7000 SERIES MAINFRAME INTERFACE CONNECTOR COVERS

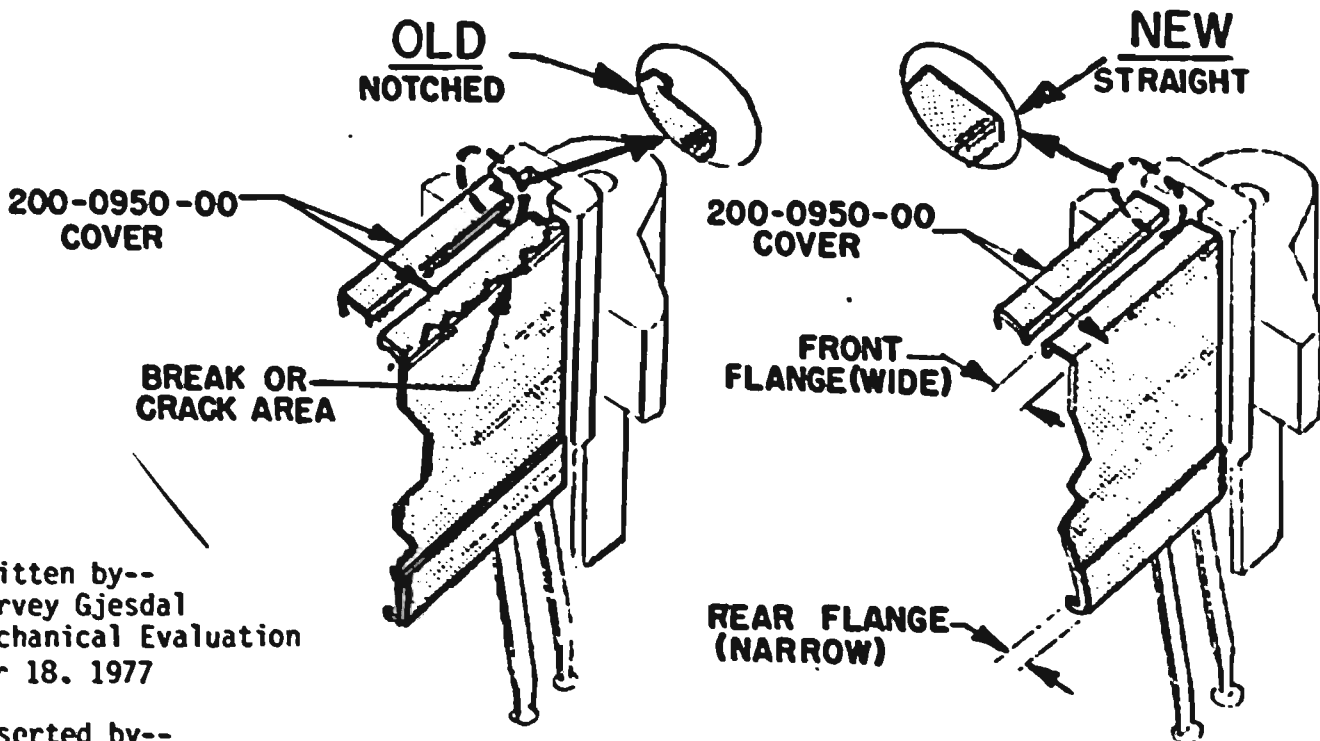
Field failures have shown up on the 200-0950-00 cover for interface connector. Breakage occurs along the front flange (see sketch). Even a slight crack can be serious, causing tension to be released on the contacts with resulting intermittence. This problem was corrected in March 1973 by small dimensional changes and a significant molding process change. The stock of old covers has been destroyed.

Sketch reveals how to distinguish between old and new covers. An adequate supply of new covers is available, PN 200-0950-00. We recommend replacement of all old covers at your earliest convenience.

Remove old cover by prying with small screwdriver to unlatch front flange from connector body; start at end.

Install new cover by holding rear flange full length against back edge of connector body while squeezing front flange into latched position on connector body. Front flange may be "zippered" into place beginning at one end.

Inspect by viewing from front. If rear flange shows bulge, remove cover as above and reinstall. If front flange shows bulge, squeeze to complete latching. If front flange extends into circuit board clearance slot, pry lightly to release it to its normal latched position.
